**San Onofre Nuclear Generating Station Unit 2 and Unit 3 GSI-191 Generic Letter
2004-02 Corrective Actions Audit Report**

Figure 3.1 Isometric View of Alion Test Tank with SONGS Prototype Strainer Installed

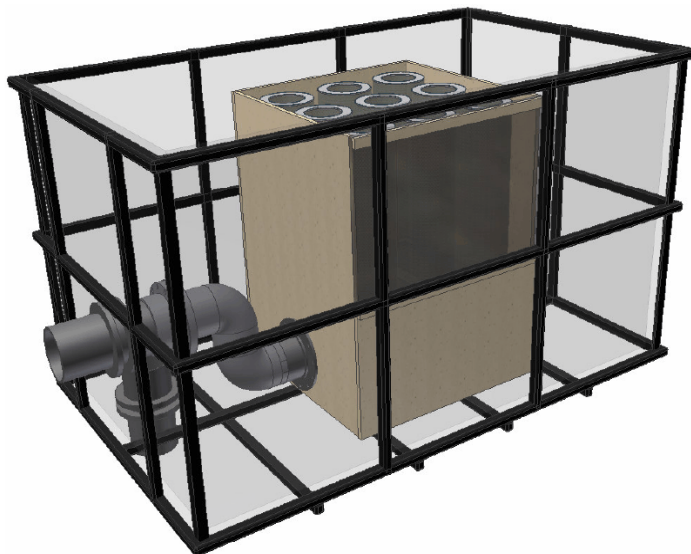
In order to demonstrate that the new strainer head loss for the most limiting LOCA cases is less than 5.0 ft, the licensee contracted with Alion to perform prototypical head loss testing. As shown in Figure 3.1, the prototype strainer was placed in a large test tank approximately 6.0 ft tall, 6.0 ft wide, and 10.0 ft long. The 3x3 Top-Hat strainer array was installed near the center of

the tank and was mounted in a plenum assembly placed on the floor of the test tank. The flow was routed from the tank inlet, through the strainer/plenum assembly, and out through one of the tank's two flow outlet channels. The outlet channels are located on the suction side of the tank near the bottom of that side. All the tests were performed with 4 plywood walls enclosing the Top-Hat strainer array as shown in Figure 3.1. Pressure transmitters, a flow meter and thermocouples were installed to measure the head loss, total flow rate and the water temperature. A total of three test series (twelve test runs) were performed to measure the head loss across the "thin bed effect" regime and capture the head loss with the maximum debris loading [74].
